UNITED STATES  
DEPARTMENT OF THE INTERIOR  
BUREAU OF LAND MANAGEMENTFORM APPROVED  
OMB NO. 1004-0135  
Expires: November 30, 2000**SUNDRY NOTICES AND REPORTS ON WELLS**  
**Do not use this form for proposals to drill or to re-enter an abandoned well. Use form 3160-3 (APD) for such proposals.**5. Lease Serial No.  
NMSF078997

**\*\* REVISED \*\* REVISED \*\* REVISED \*\* REVISED \*\* REVISED \*\* REVISED \*\* REVISED \*\***

**WELL NAME:** San Juan30-5 Unit #266A

**DRILLING PROGNOSIS**

San Juan 30-5 Unit #266A

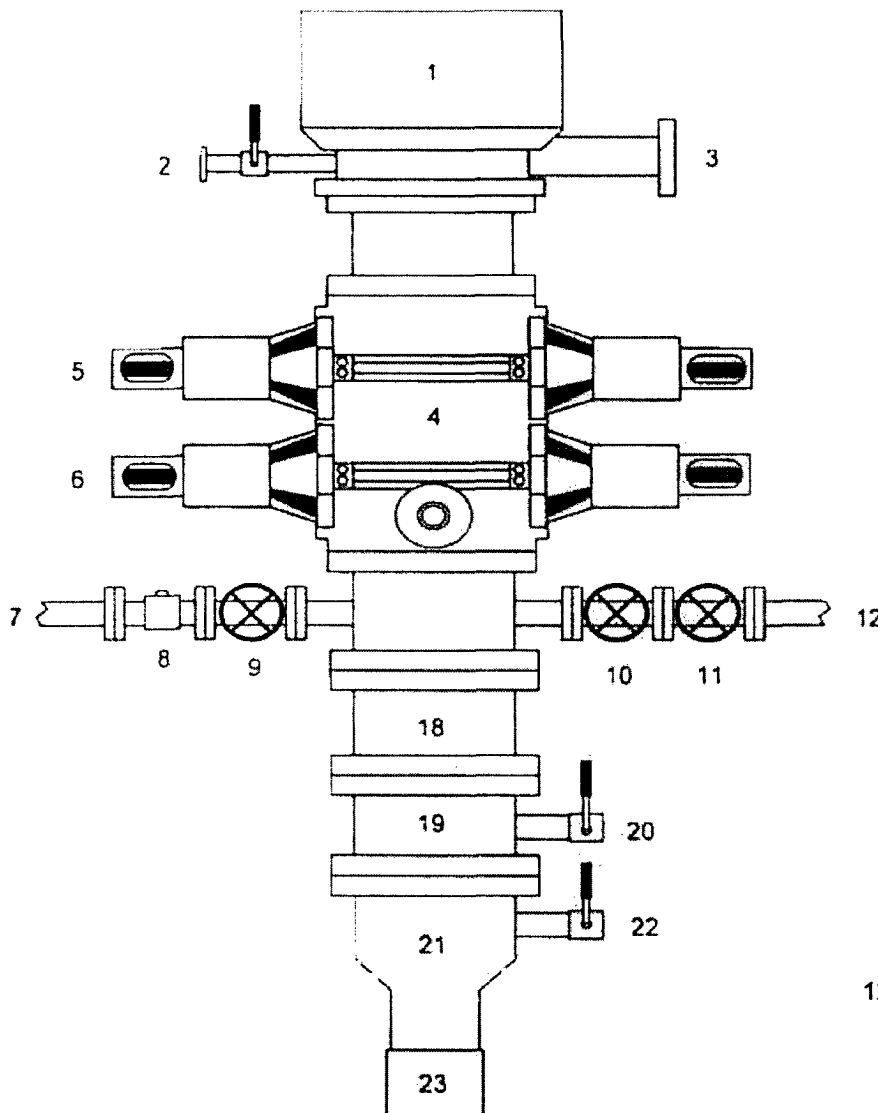
#9. Cement Program: Liner-if the coal is NOT clefted, a 4-1/2" 11.6#, J/K-55 liner will be run & set @ TD and tie 200' into the 7" shoe. It then would be cement in place. The well will be completed by fracture stimulation.

Will cement the Lead Slurry with Type III cement - 150% excess casing hole annular volume with Type III cement + 0.25#/sx Cello-flake + 5#/sx Gilsonite + 6% bwoc Bentonite + 10#/sx CSE + 3% bwow KCl + 4% bwoc FL-25 mixed + 0.2#/sx static free mixed at 10. ppg (2.52 cf/sx yield).

Tail - 50 sx Type III cement + 0.2#/sx Cello-flake + 1% CaClum Chloride mixed at 14.5 ppg (1.40 cf/sx yield = 70 cf).

If the coal is cleated a 5 ½" 15.5# liner will be run in the open hole without being cemented.

If the coal is not cleated, a 4-1/2" 11.6# liner will be run & cemented. The well will then be completed by fracture stimulation.
